Dear Inspectorate,

In response to your request for additional information relating to Norton Brook flooding following my OFH 1 comments:

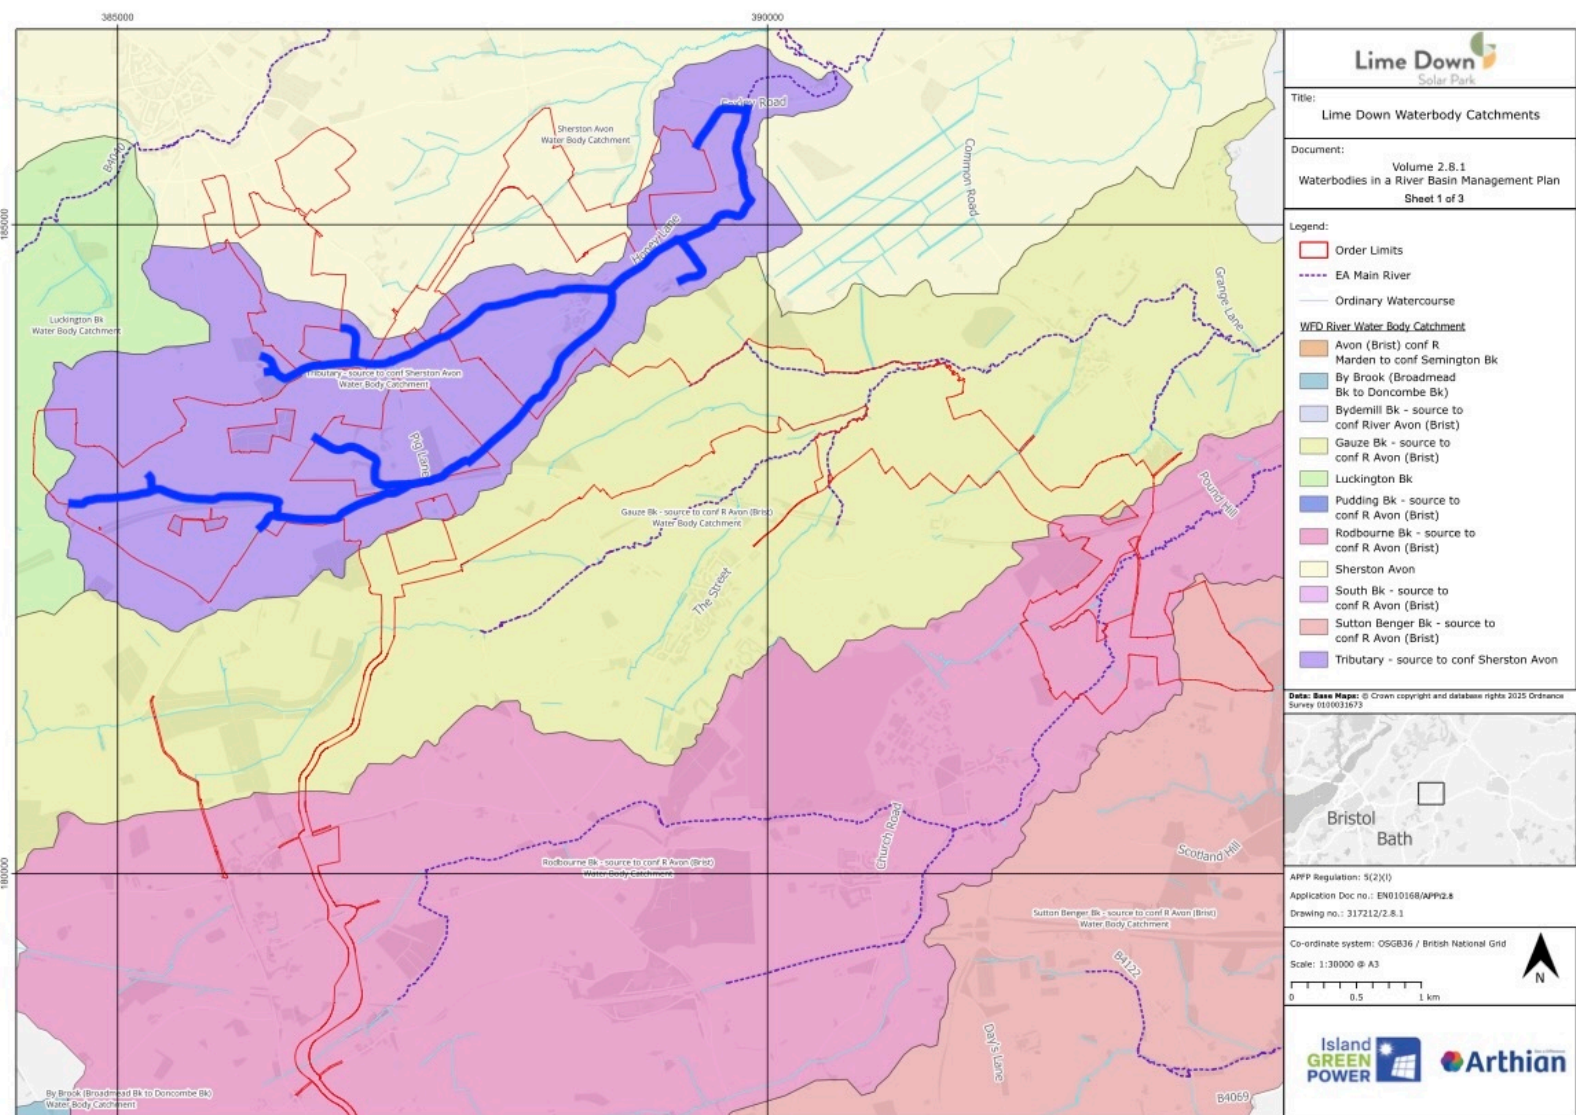
3) Proposed Development: A map of the Norton Brook catchment area overlaid with the location of the proposed Development sites can be found in Application document APP-012 - EN010168/APP/2.8 - “Waterbodies in a River Basin Management Plan” on page 3 (labelled as Sheet 1) and highlighted in purple. For clarity, I have provided a copy of that sheet below, highlighting the extent of the Norton Brook water courses in dark blue.
